Repository Design and Thermal-Mechanical Effects

**DOE/NRC Technical Exchange on the Key Technical Issue
and Subissues Related to Repository Design and Thermal-
Mechanical Effects**

**February 6-8, 2001
Las Vegas, NV**

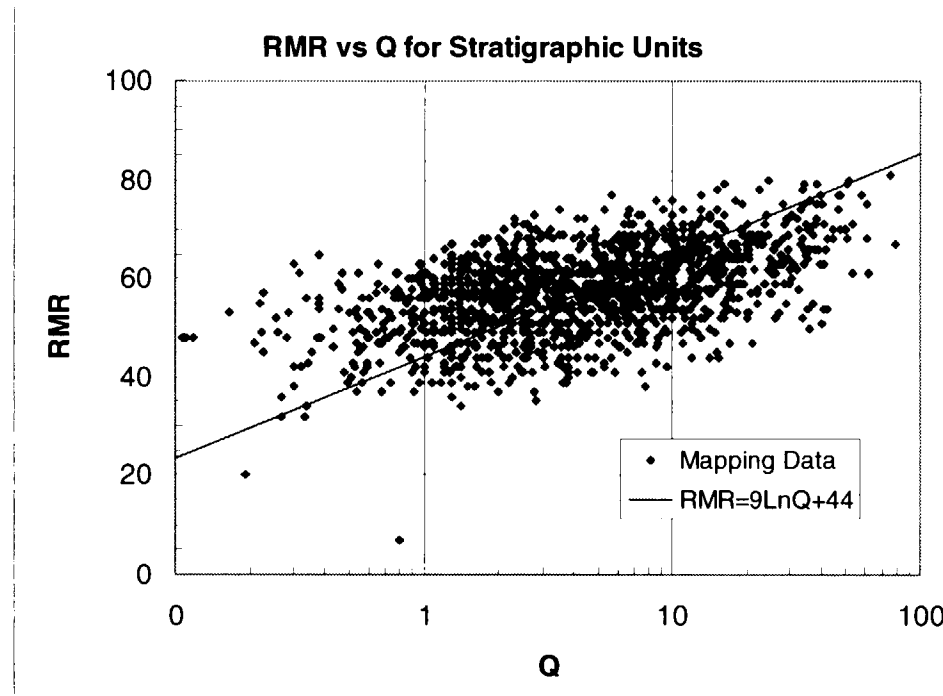
- **Design analyses use appropriate models and site-specific properties of the host rock and consider spatial and temporal variation and uncertainties in such properties**
- **Action or Information Needs**
 - Justify mechanical properties for continuum rock mass modeling
 - Justify mechanical properties for discontinuum rock mass modeling
 - Provide basis for mechanical degradation of rock support materials
 - Justify thermal-mechanical modeling
- **Basis for Closure**
 - Ground support analyses have considered the site conditions, postulated loadings, and available modeling approaches
 - Ground support analyses have considered combinations of continuum and discontinuum modeling methods

- **DOE's continuum and discontinuum models are appropriate for their intended use and are adequately justified. DOE considers this acceptance criterion to be Closed-Pending completion of**
